Title - Sujet Underground Pipeline Replacement	
Solicitation No. - N° de l'invitation EP076-180009/A	Amendment No. - N° modif. 001
Client Reference No. - N° de référence du client 20180009	Date 2017-09-25
GETS Reference No. - N° de référence de SEAG PW-\$\$\$FG-343-73387	
File No. - N° de dossier fg343.EP076-180009	CCC No./N° CCC - FMS No./N° VME
Solicitation Closes - L'invitation prend fin at - à 02:00 PM on - le 2017-09-28	Time Zone Fuseau horaire Eastern Daylight Saving Time EDT
F.O.B. - F.A.B. Plant-Usine: <input type="checkbox"/> Destination: <input type="checkbox"/> Other-Autre: <input type="checkbox"/>	
Address Enquiries to: - Adresser toutes questions à: Cook, Kristin	Buyer Id - Id de l'acheteur fg343
Telephone No. - N° de téléphone (819) 956-6122 ()	FAX No. - N° de FAX (819) 775-7409
Destination - of Goods, Services, and Construction: Destination - des biens, services et construction: Health Canada/ Sante Canada Edifice Sir Frederick Banting Building 251 Edifice Sir Frederick Banting Building Ottawa, Ontario K1Y 0M1

Amendment 001 is issued for the following:

ADDENDUM No. 01
Project Number: R.082933.100

1 FIRST FLOOR - NEW CONSTRUCTION / PREMIER ÉTAGE - NOUVELLE CONSTRUCTION
SCALE = 1:125
A101

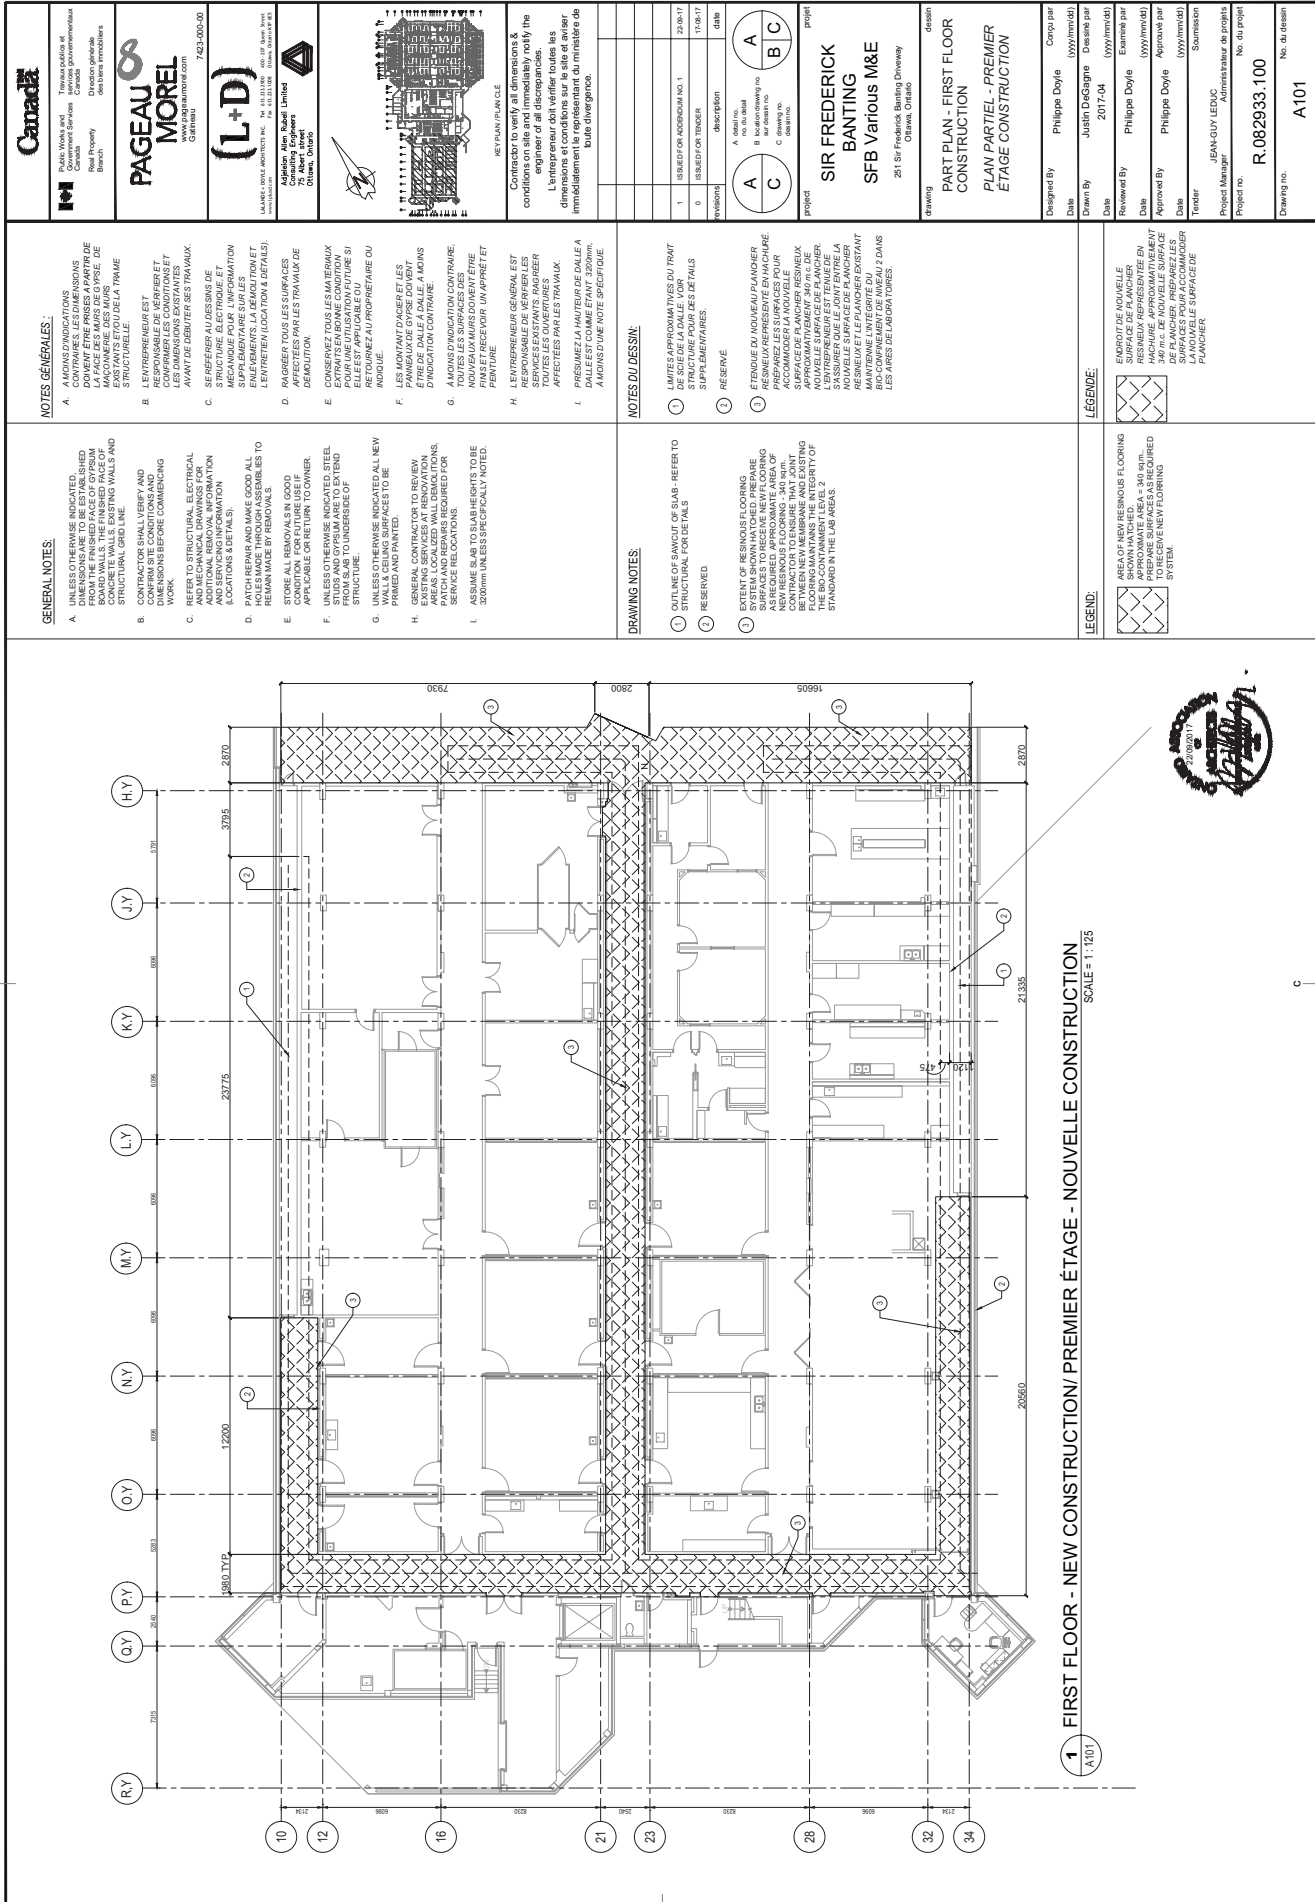
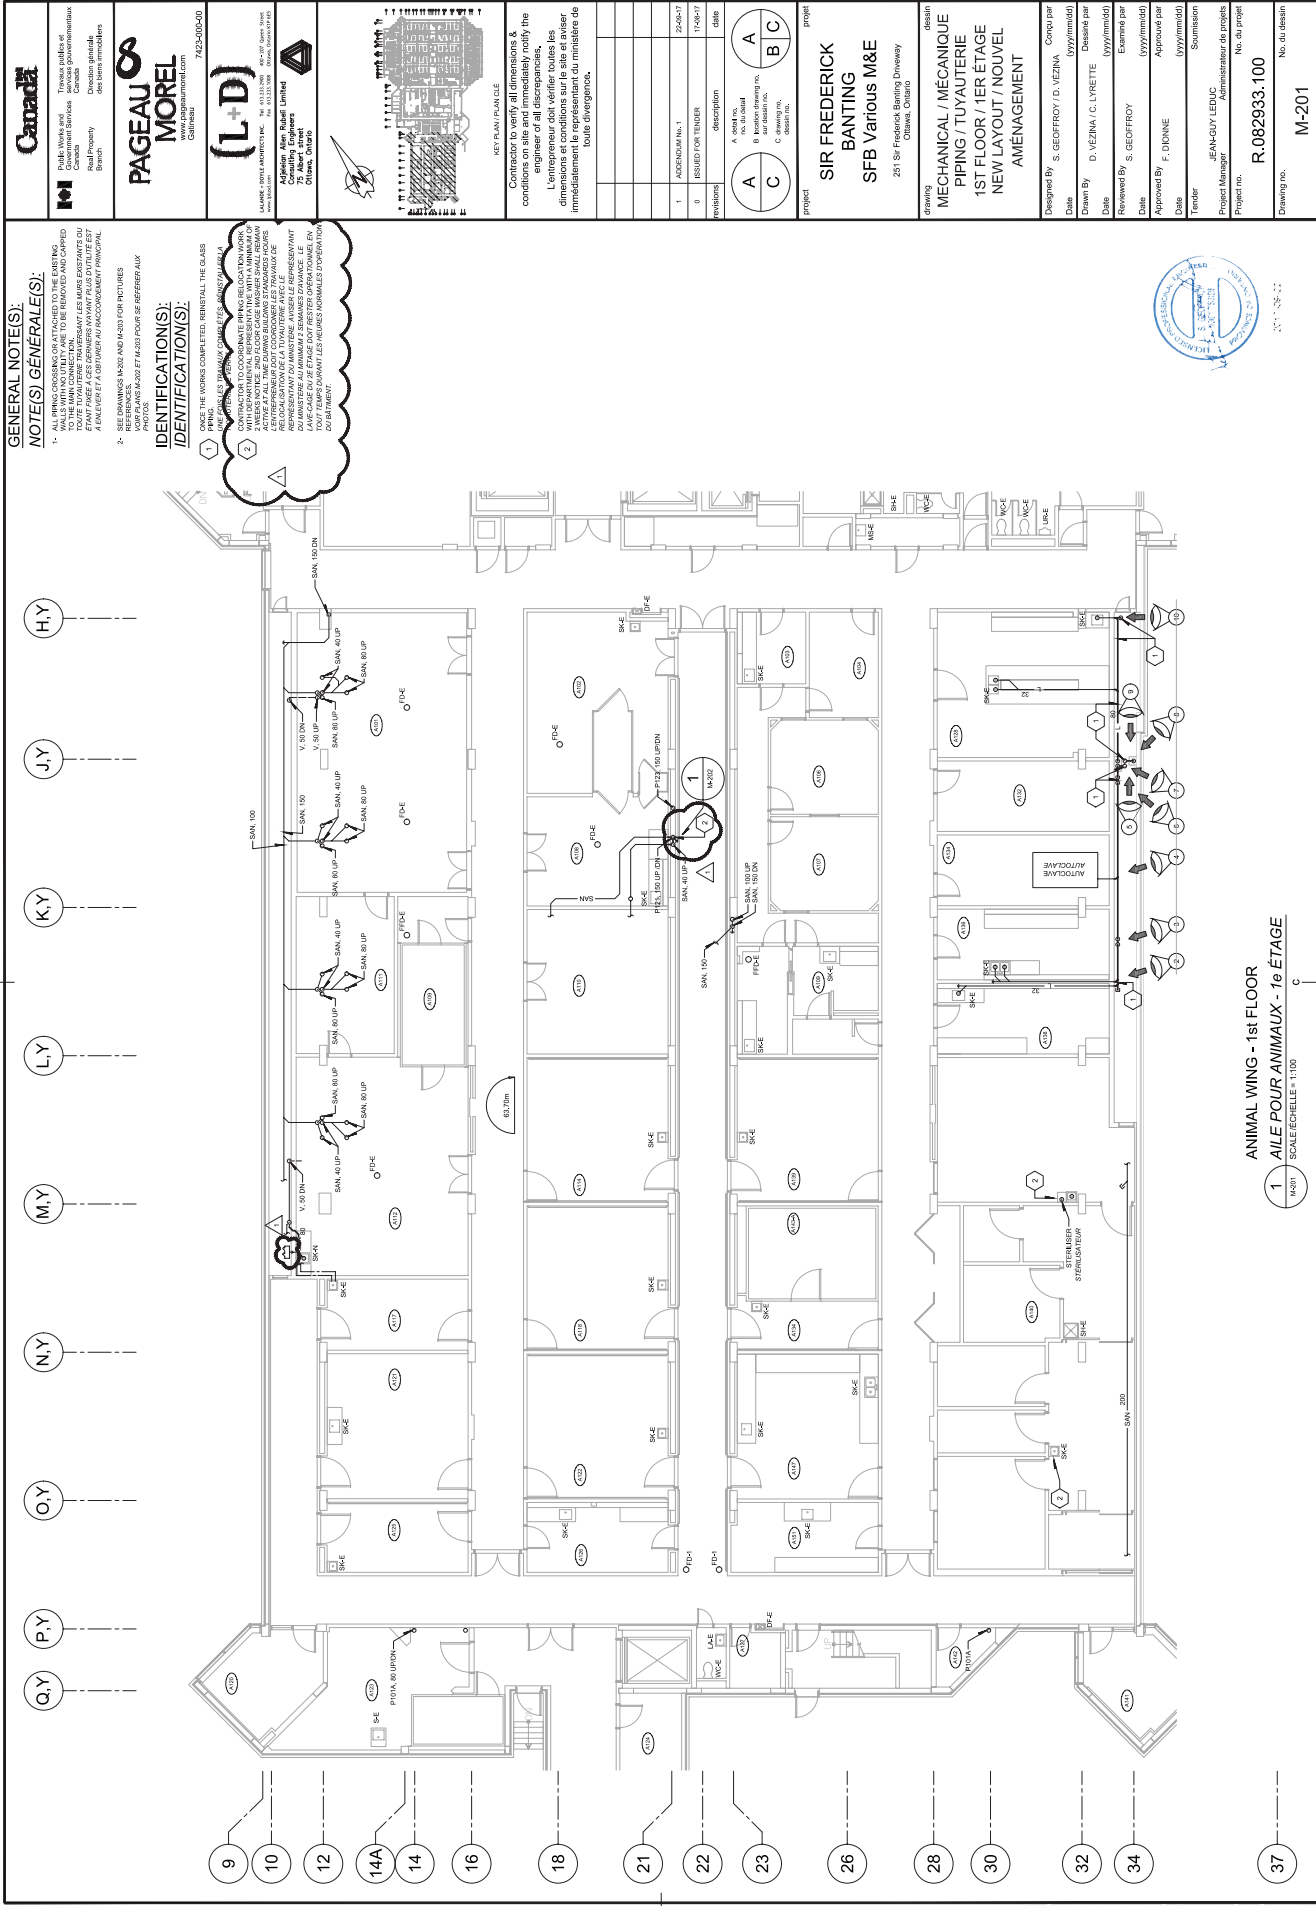
What type of flooring is in the clean room?

- .1 A-100 - Architecture – Part Plan – First Floor Demolition
 - .1 Delete drawing A-100, revision 0, 2017-08-17 entirely.
Replace with drawing A-100, revision 1, 2017-09-22.
- .2 A-100 - Architecture – Part Plan – First Floor Construction
 - .1 Delete drawing A-101, revision 0, 2017-08-17 entirely.
Replace with drawing A-101, revision 1, 2017-09-22.
- .3 M-001 – Mechanical – Electrical – Legend
 - .1 Delete drawing M-001, revision 0, 2017-08-17 entirely.
Replace with drawing M-001, revision 1, 2017-09-22.
- .4 MD-201 – Mechanical – Piping – 1st Floor – Demolition
 - .1 Delete drawing MD-201, revision 0, 2017-08-17 entirely.
Replace with drawing MD-201, revision 1, 2017-09-22.
- .5 M-201 – Mechanical – Piping – 1st Floor – New Layout
 - .1 Delete drawing M-201, revision 0, 2017-08-17 entirely.
Replace with drawing M-201, revision 1, 2017-09-22.

Please refer to Addendum 01 below.

- OUTLINE OF SAWCUT OF SLAB - REFER TO STRUCTURAL FOR DETAILS
- RESERVED
- EXTENT OF RESINOUS FLOORING SURFACES TO BE REMOVED. PREPARE NEW RESINOUS FLOORING - 360 sqm. NEW RESINOUS FLOORING TO BE LAYED BETWEEN NEW MEMBRANE AND EXISTING FLOORING MAINTAINING THE INTEGRITY OF FLOORING SYSTEM.
